APPEAL SUMMARY

| Appeal ID: 20436 | Project Address: 7119 SE Knight St |
| Appeal Type: Plumbing | Plans Examiner/Inspector: Joe Blanco, McKenzie James, Jason Butler-Brown |

| Code Section | Stormtech setbacks |

Appeal item 1

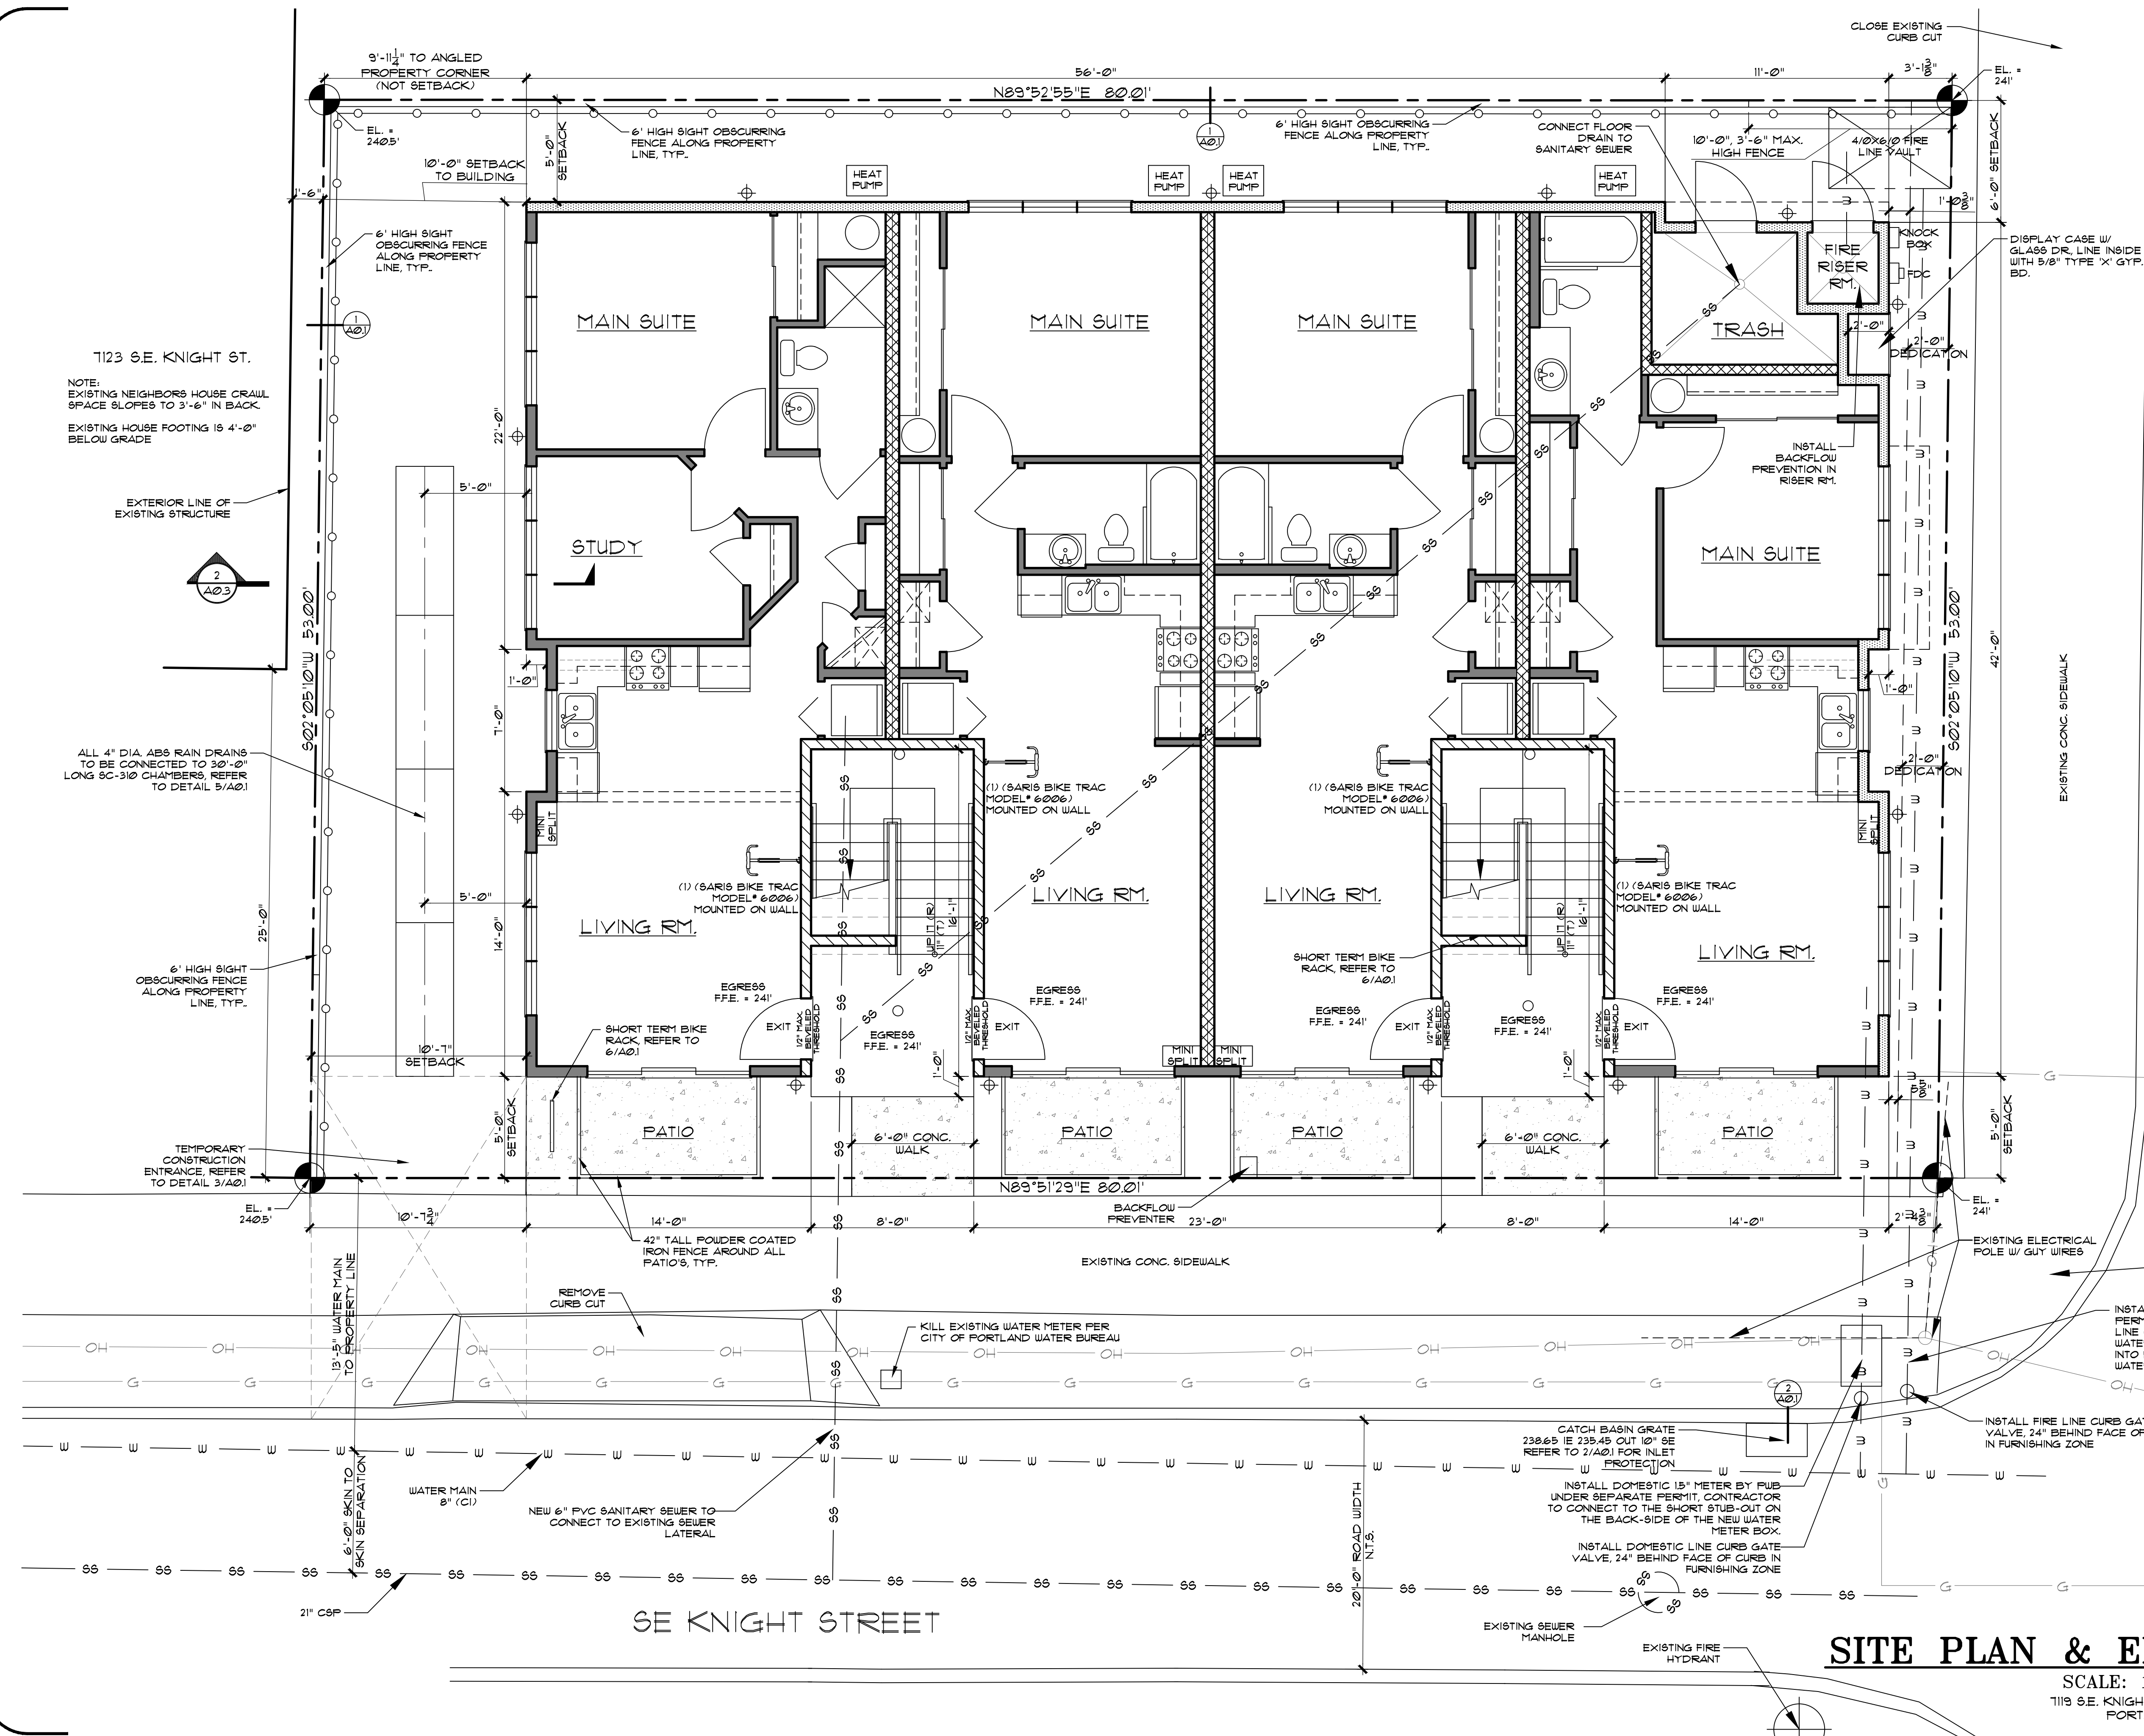
| Requires | The plumbing code requires a 5 foot setback from a property line and 10 feet to a building foundation to the edges of the stormtech SC310 piping which means a required 18 foot wide yard. |
| Proposed Design | Attached Is the requested letter from the Geotech. engineer stating the stormtech system will not impact the building foundation Also attached is a cross section thru the storm system adjacent to the building and property line' |

Location of Storm Tech chambers within 10 feet of building foundation: Granted as proposed.

1 PLUMBING LAYOUT
A0.3 NO SCALE:

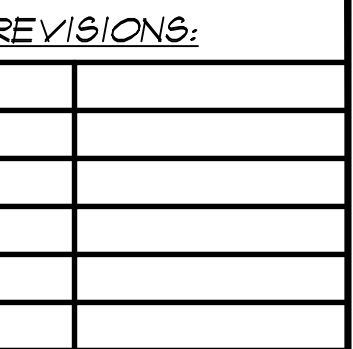
Based on the cross section of the adjacent building, the stormtech chamber, and the proposed building, the initial concerns have been resolved. I will support the approval of the appeal.
